AGREEMENT

STORM DAMAGE REPAIR TO ALDERPOINT ROAD
(F6B165) PM 2.10, 2.70 & 2.98
PROJECT NO.: ER-32L0(268/270/271)
CONTRACT NO.: 217245, 217247, 217248

CONTRACT CHANGE ORDERChange Requested by: Engineer ☒ Contractor ☐

SHEET
6a
OF
42

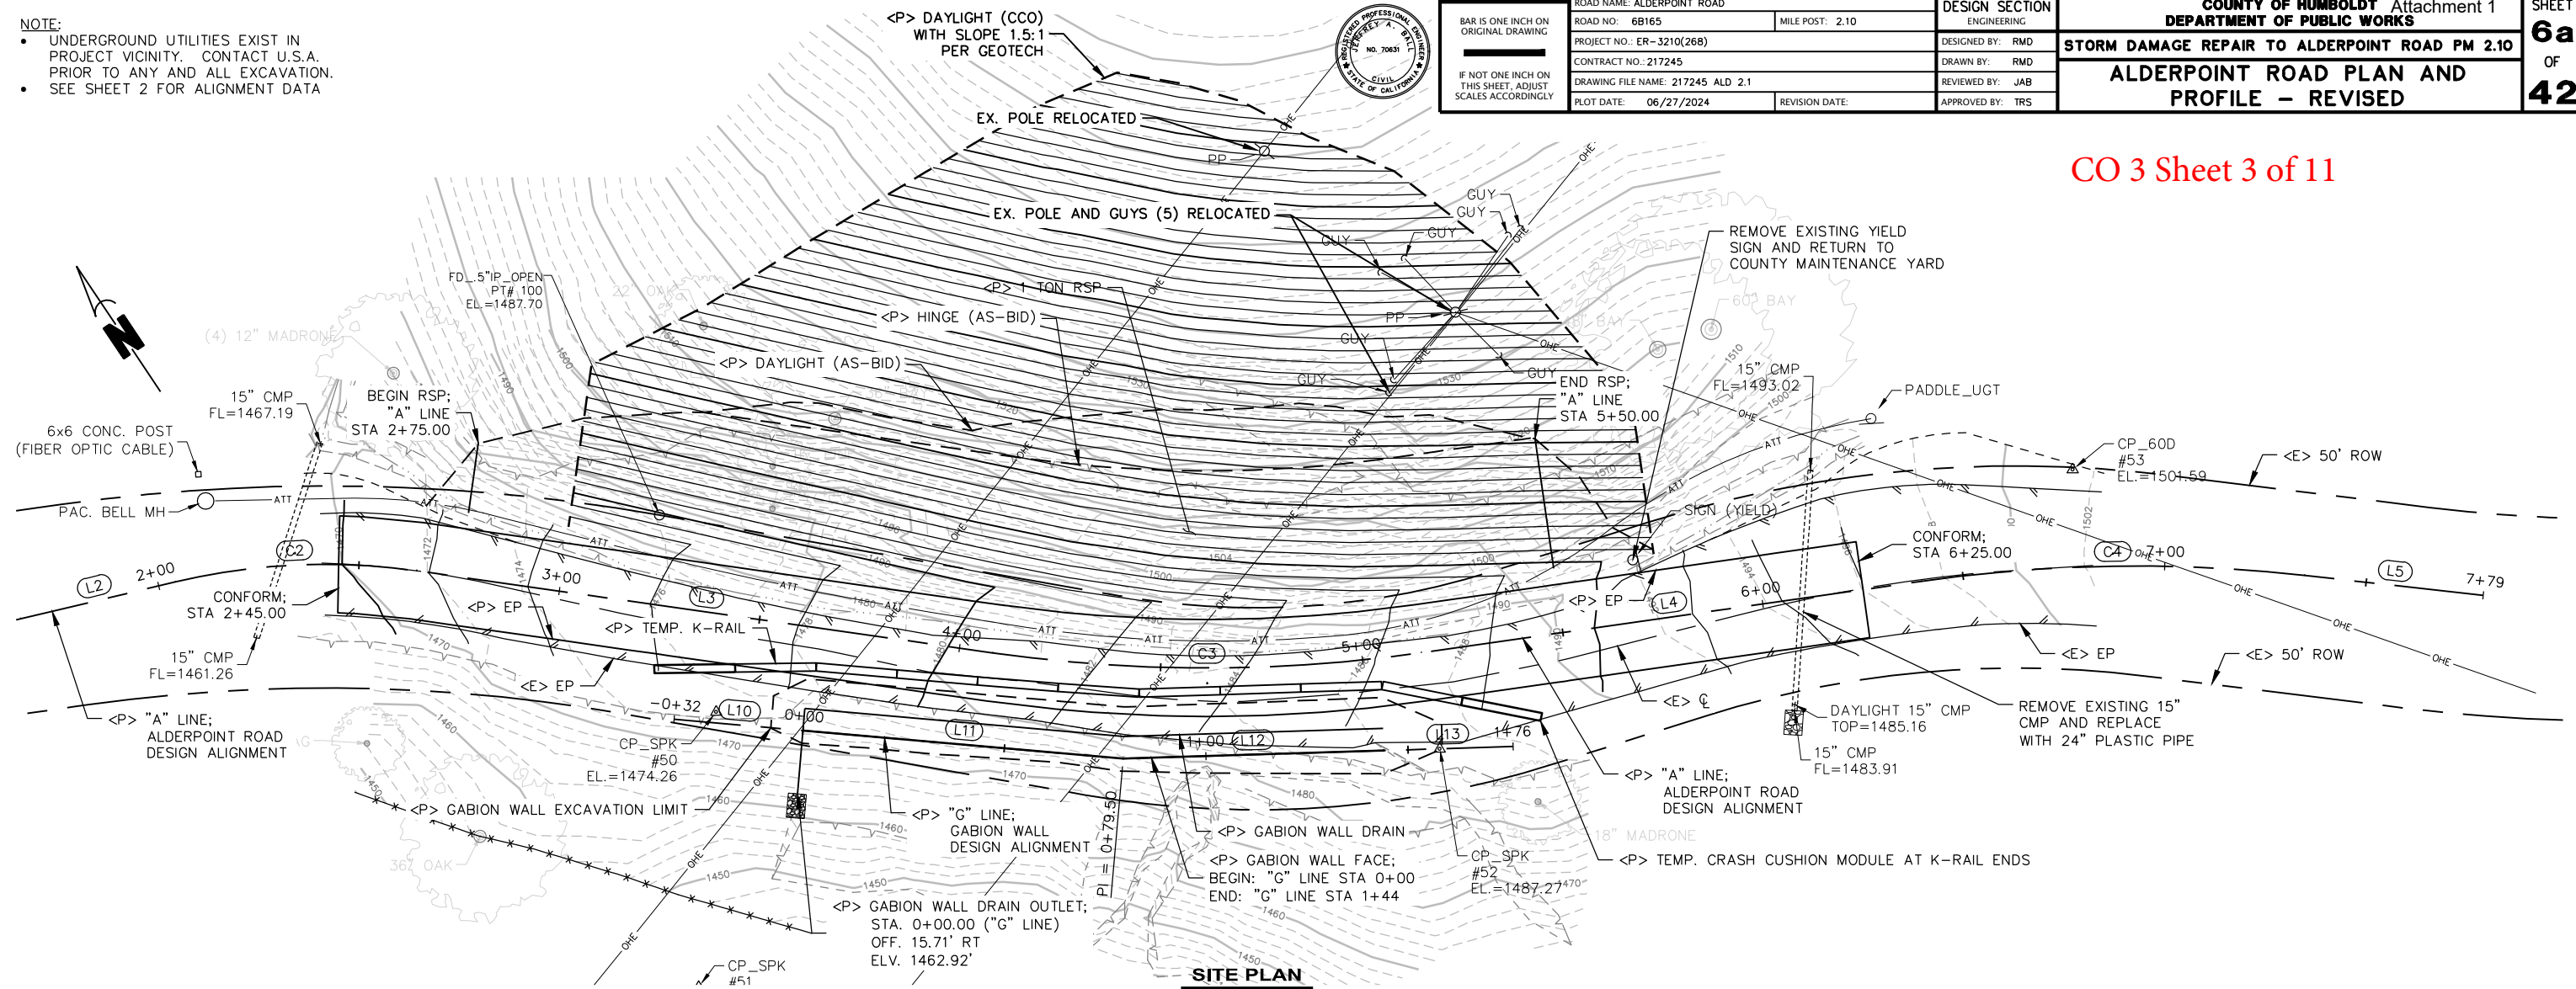
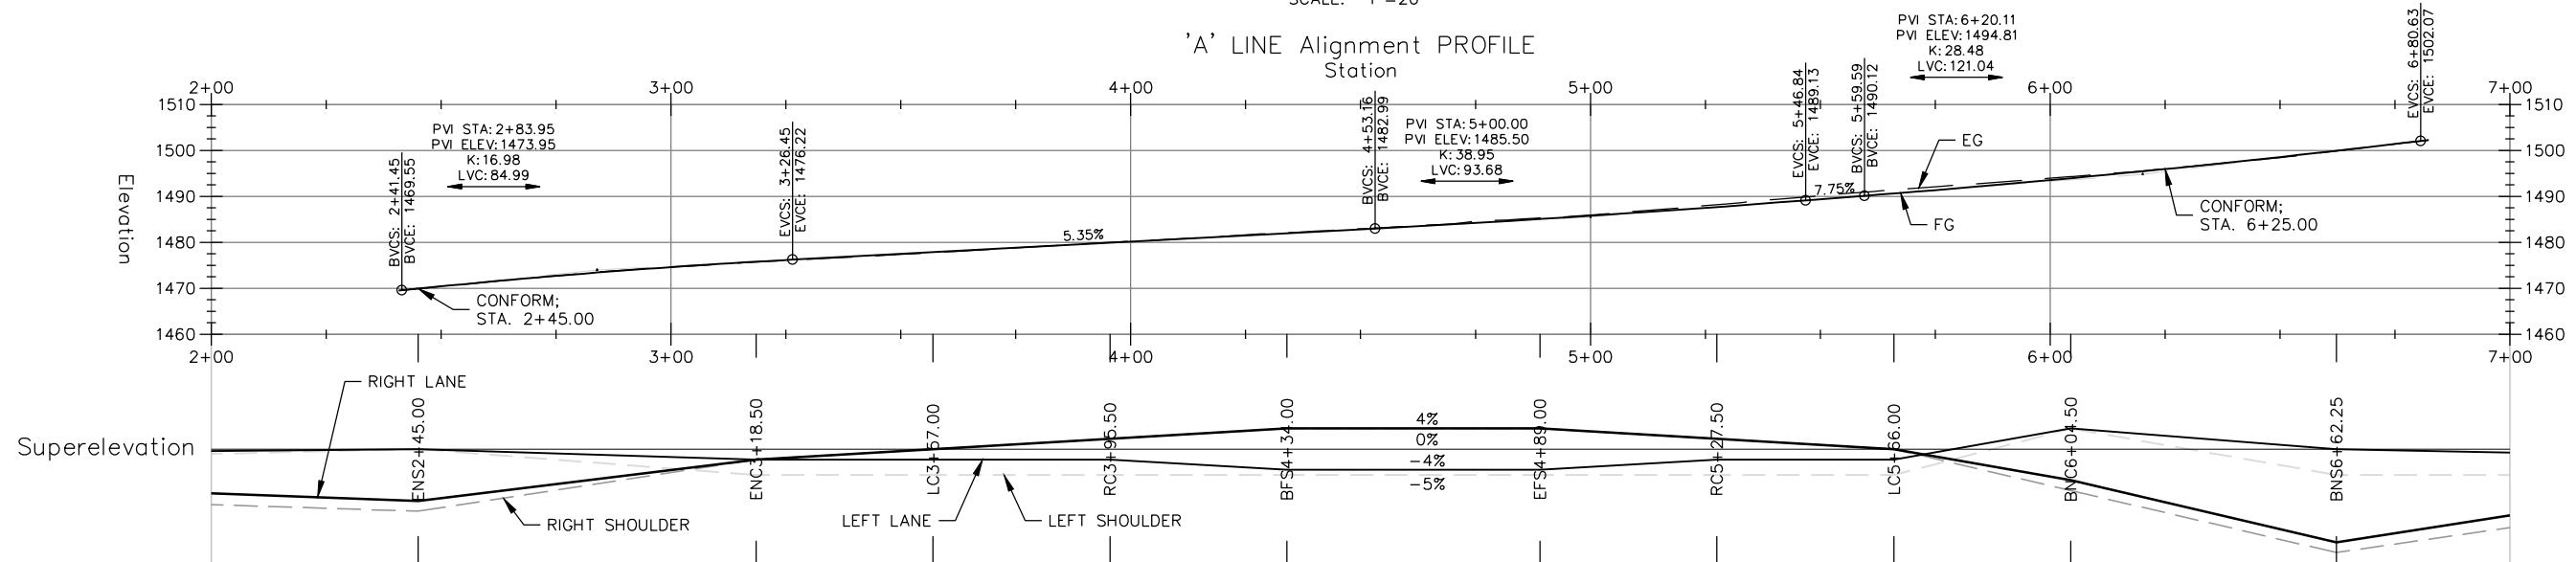
In accordance with Section 4-1.05 "Changes and Extra Work" of the Standard Specifications, replace sheets 6, 8, and 9 of the project plans with the attached plan sheets 6a, 8a-d, and 9a-d. Install 36" OMP and 18" Culvert near Sta 2+30 as directed by the Engineer.

- Provide personnel to monitor the slide activity
- Provide additional traffic control
- Install trench drain
- Locate utilities
- Remove RSP placed to mitigate slide activity

For this work, the contractor shall receive and accept a lump sum of \$157,834.51. This sum constitutes full and complete compensation for furnishing all labor, material, equipment, tools, and incidentals including all markups by reason of this change.
